XE166M Derivatives

Edition 30.01.2009

Table of Contents

Figure 1 Loss of Arbitration

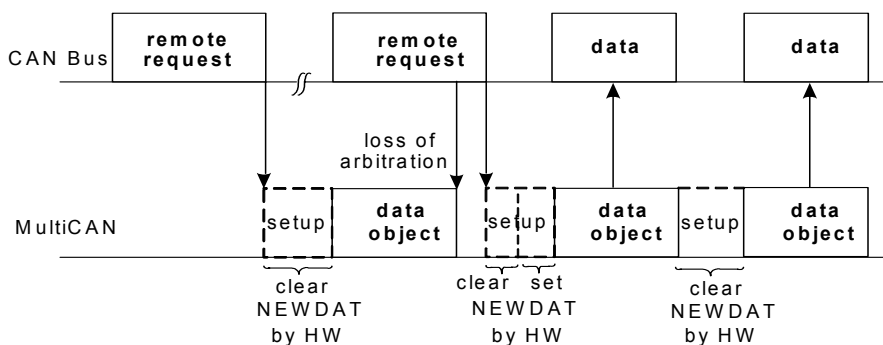
MultiCAN_TC.H004 Double remote request

Assume the following scenario: A first remote frame (dedicated to a message object) has been received. It performs a transmit setup (`TXRQ` is set) with clearing `NEWDAT`. MultiCAN starts to send the receiver message object (data

frame), but loses arbitration against a second remote request received by the same message object as the first one (`NEWDAT` will be set).

When the appropriate message object (data frame) triggered by the first remote frame wins the arbitration, it will be sent out and `NEWDAT` is not reset. This leads to an additional data frame, that will be sent by this message object (clearing `NEWDAT`).

There will, however, not be more data frames than there are corresponding remote requests.
